Reedsburg Human Services Cameras and Paging system upgrade
Addendum 1.2

Tower Site Camera location

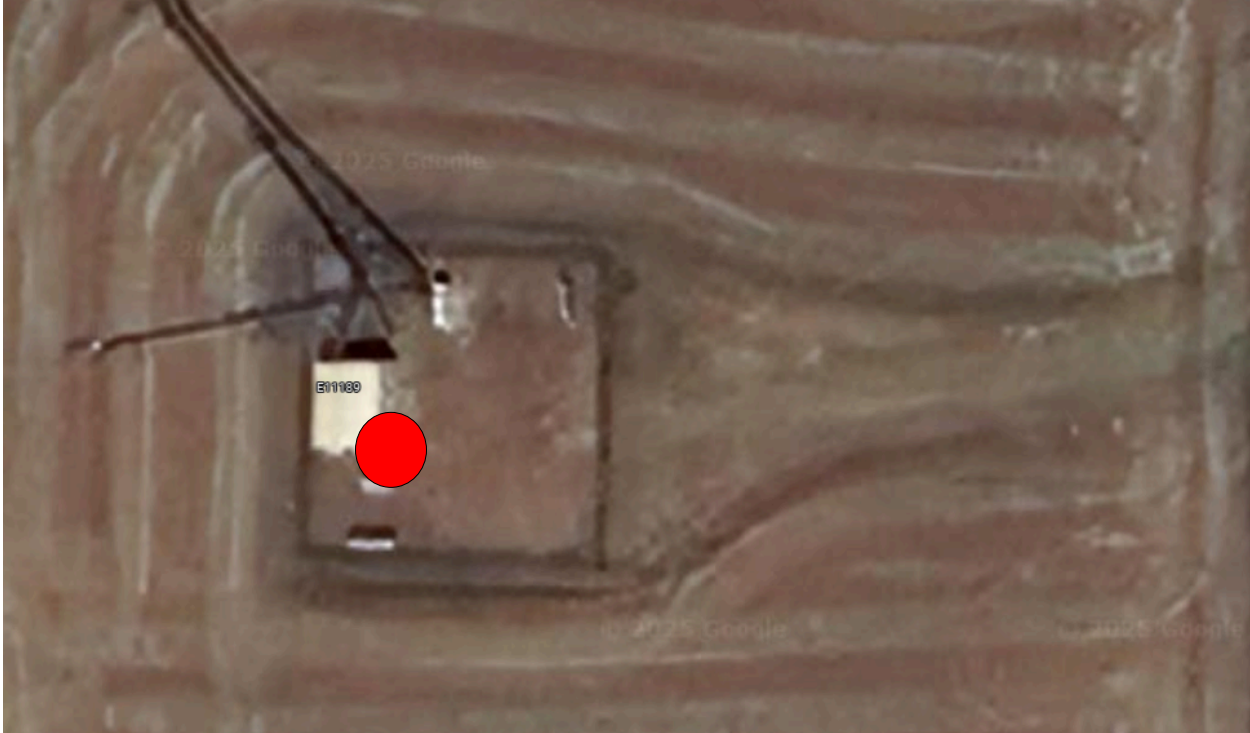
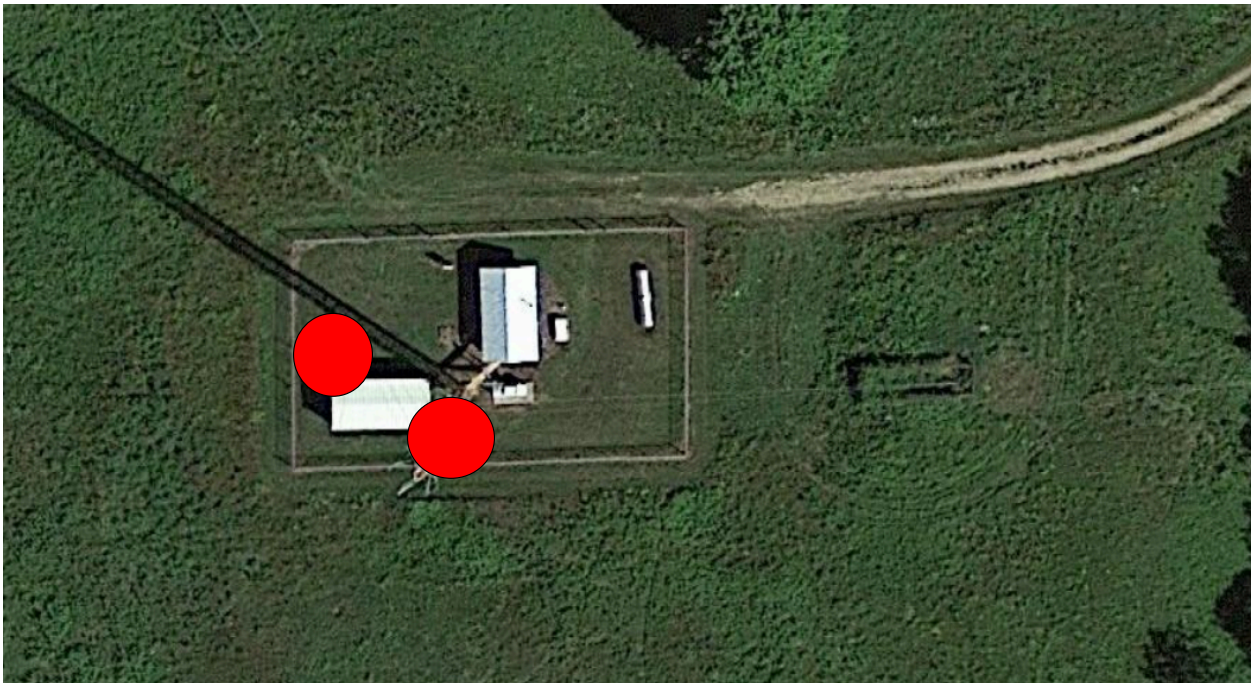
7. Also, I see that Sauk County is providing cabling and connections at each tower location. Will the height of each camera be obvious to our techs in the field? And will this be ladder high or lift high?

11. For the towers, do we need a recording device for each tower, or will the cameras be recording over the network back to the server?

12. For the cameras at the tower are you wanting SD cards, if so, what size?

The height of the cameras will be set at 10-12' off the ground level on the corners of the building. A junction box will be set for the cat 6 connection to the corner mounted camera. All camera mounting work can be completed from a ladder

Cameras are going to be networked back the Reedsburg Human Services NVR

No., Camera are to be networked and need to meet spec 2.6 of the RFP
